Braidwood Station, Units 1 and 2
Facility Operating License Nos. NPF-72 and NPF-77
NRC Docket Nos. STN 50-456 and STN 50-457

Byron Station, Units 1 and 2
Facility Operating License Nos. NPF-37 and NPF-66
NRC Docket Nos. STN 50-454 and STN 50-455

Subject: Request for Technical Specifications Change
Expanded Core Operating Limits Reports

DESCRIPTION AND SAFETY ANALYSIS FOR PROPOSED CHANGES

Figure 2.1.1-1 (page 1 of 1)
Reactor Core Safety Limits

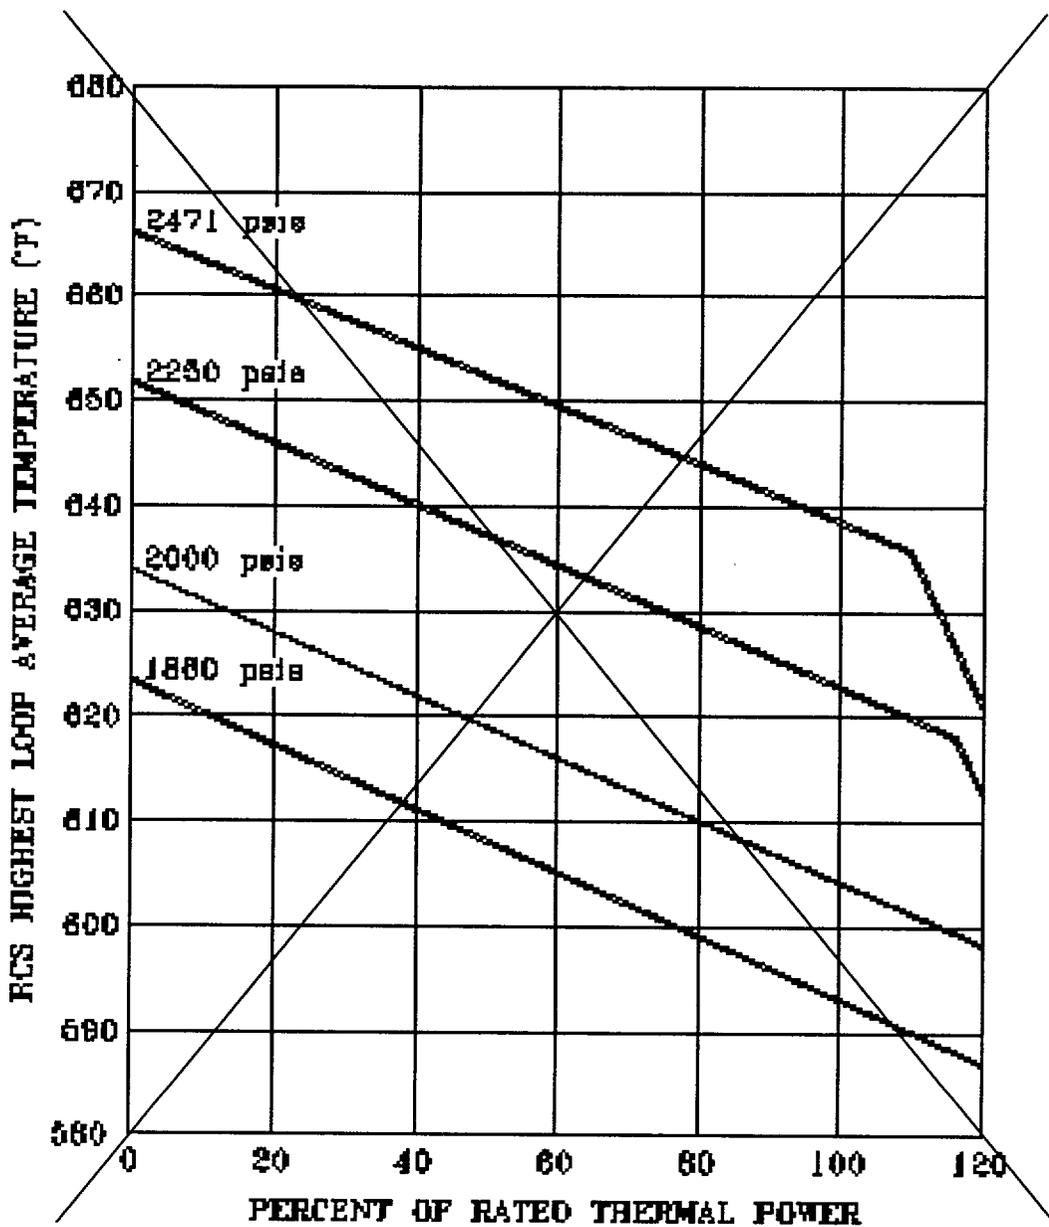
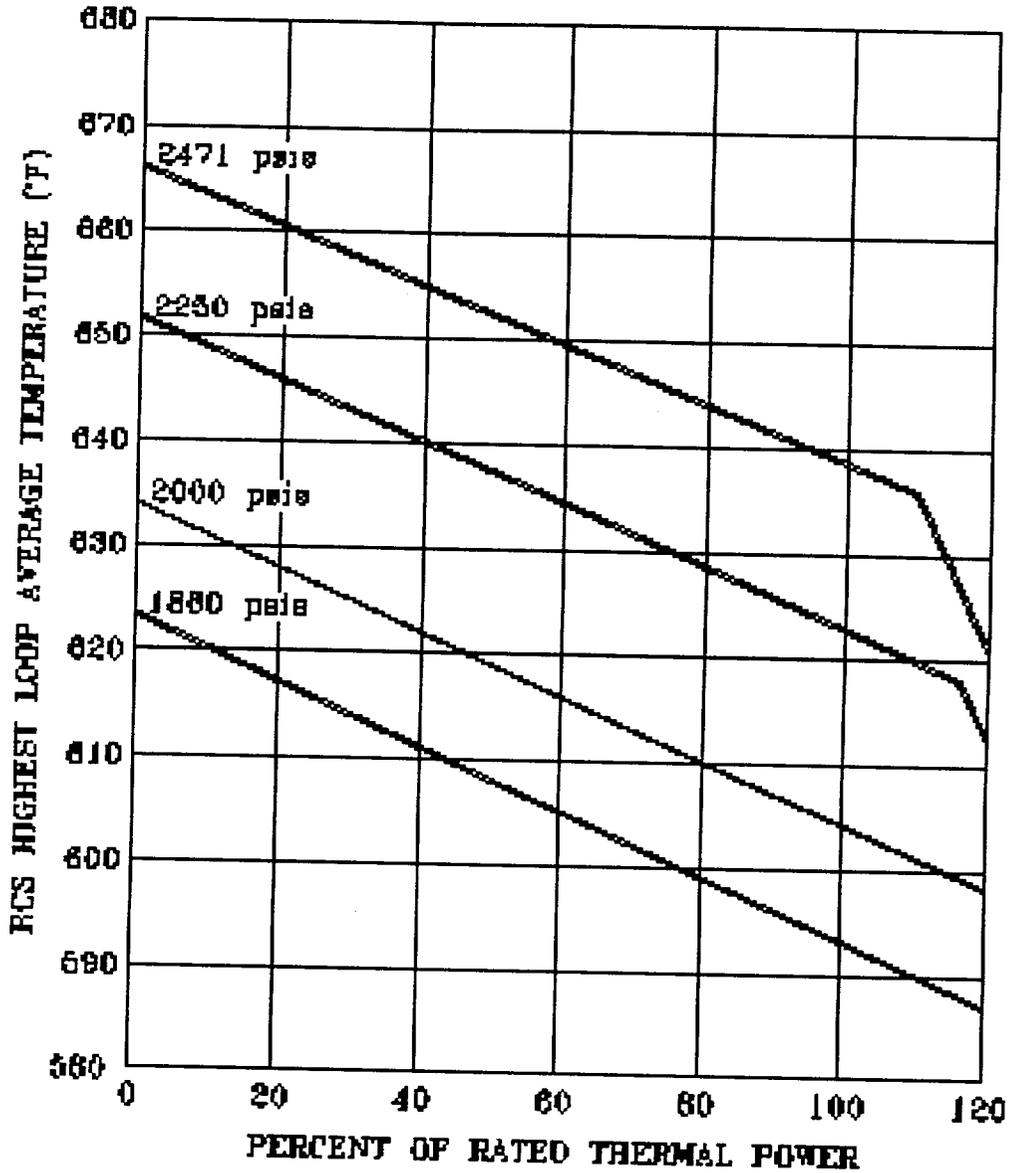
TS Figure 2.1.1-1, "Reactor Core Safety Limits," is being relocated to the COLR for each of the four units, and is being replaced with more specific fuel DNBR and peak fuel centerline temperature safety limits.

Relocating the RCSL figure to the COLRs would eliminate the possibility of reaching an incorrect conclusion concerning whether or not a safety limit has been violated for a Condition I or II event. Additionally, removal of the RCSL figure would prevent the possibility of misusing the RCSL figure to define an "acceptable" operating configuration that could result in the plant being placed in an unanalyzed condition.

It is proposed that the RCSL figure be replaced with the DNB design basis limit and the fuel centerline melting limit as these limits are criteria that must be satisfied for all Condition I and II transients. Confirming that the RPS and the MSSVs are functioning as designed will ensure that both the DNB design basis and fuel centerline melting criteria are satisfied for any Condition I or II event. With this approach, the chance of reaching an incorrect conclusion with respect to the safety limits would be greatly reduced, if not eliminated.

~~In MODES 1 and 2, the combination of THERMAL POWER, Reactor Coolant System (RCS) highest loop average temperature, and pressurizer pressure shall not exceed the SLs specified in Figure 2.1.1 1.~~

DELETE FIGURE

Relocated figure

Figure B 2.1.1-1 (page 1 of 1)
Reactor Core Safety Limits vs. Boundary of Protection

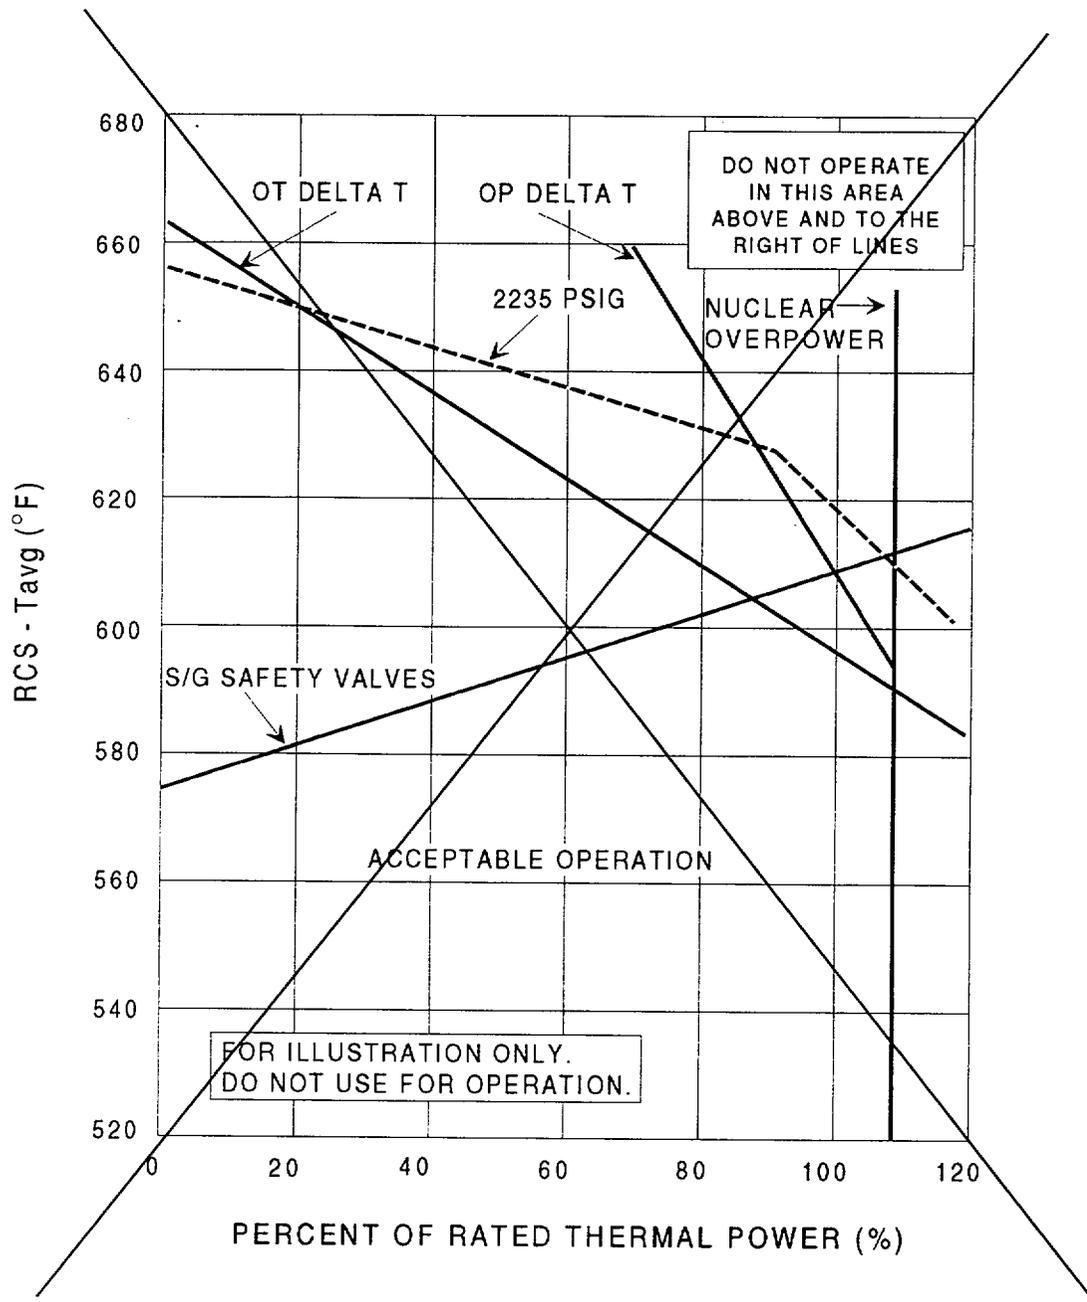
~~Figure B 2.1.1-1 shows an example of the reactor core safety limits of THERMAL POWER, RCS pressure, and average temperature for which the minimum DNBR is not less than the safety analyses limit, that fuel centerline temperature remains below melting, that the average enthalpy in the hot leg is less than or equal to the enthalpy of saturated liquid, or that the core exit quality is within the limits defined by the DNBR correlation.~~

~~The curves are typically derived based on enthalpy hot channel factor limits such as those provided in the COLR. The dashed line of Figure B 2.1.1-1 shows an example of a limit curve at 2235 psig. In addition, it illustrates the various RPS functions that are designed to prevent the unit from reaching the limit.~~

DELETE FIGURE

Figure 2.1.1-1 (page 1 of 1)
Reactor Core Safety Limits

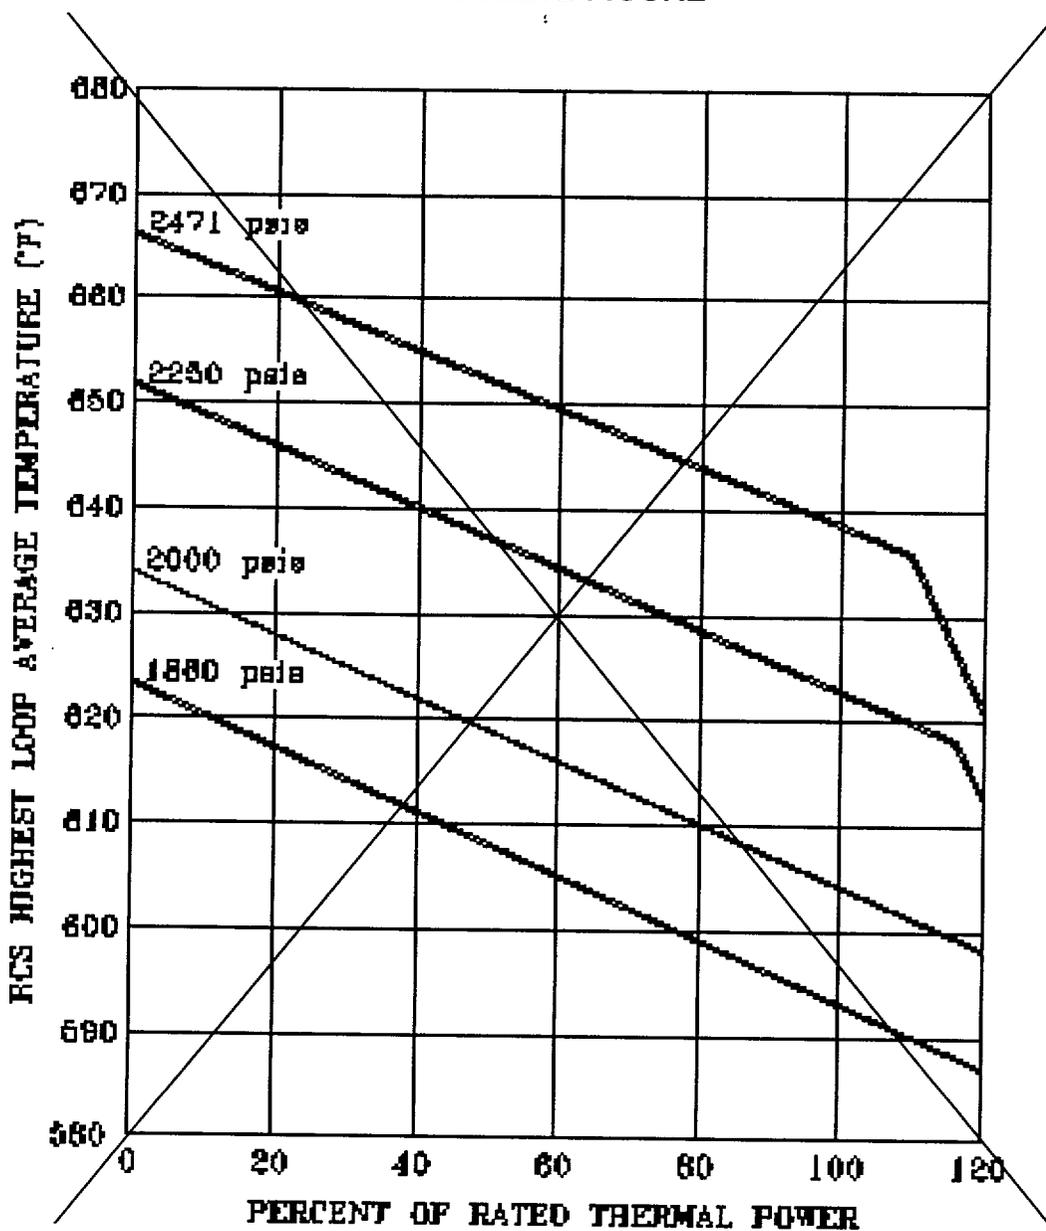
~~In MODES 1 and 2, the combination of THERMAL POWER, Reactor Coolant System (RCS) highest loop average temperature, and pressurizer pressure shall not exceed the SLs specified in Figure 2.1.1.1.~~

DELETE FIGURE

Figure B 2.1.1-1 (page 1 of 1)
Reactor Core Safety Limits vs. Boundary of Protection

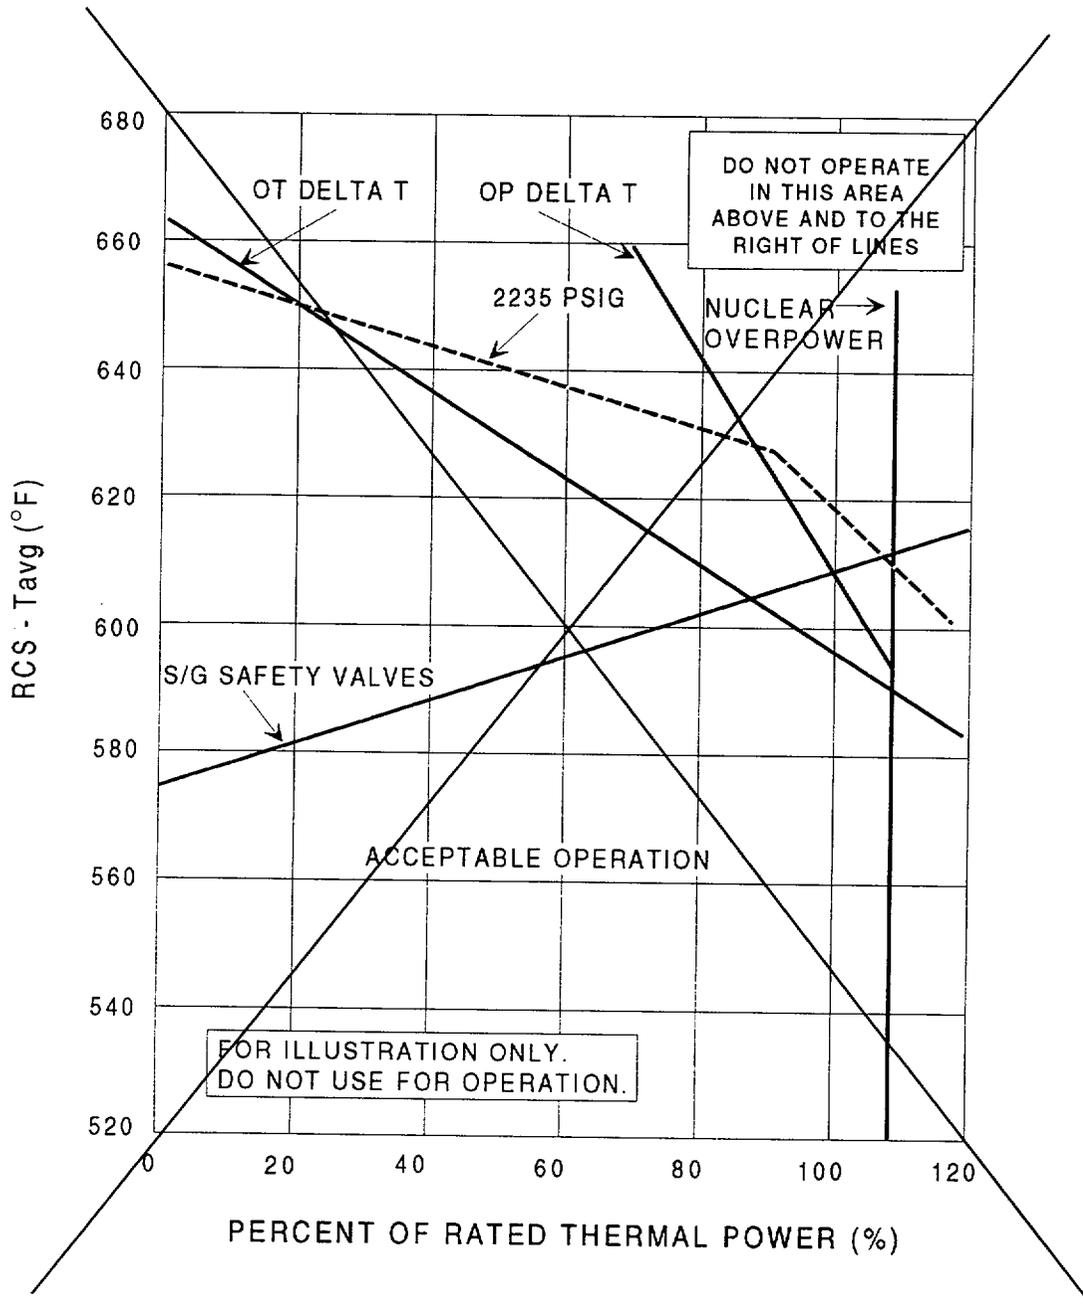
~~Figure B 2.1.1 1 shows an example of the reactor core safety limits of THERMAL POWER, RCS pressure, and average temperature for which the minimum DNBR is not less than the safety analyses limit, that fuel centerline temperature remains below melting, that the average enthalpy in the hot leg is less than or equal to the enthalpy of saturated liquid, or that the core exit quality is within the limits defined by the DNBR correlation.~~

~~The curves are typically derived based on enthalpy hot channel factor limits such as those provided in the COLR. The dashed line of Figure B 2.1.1.1 shows an example of a limit curve at 2235 psig. In addition, it illustrates the various RPS functions that are designed to prevent the unit from reaching the limit.~~

DELETE FIGURE
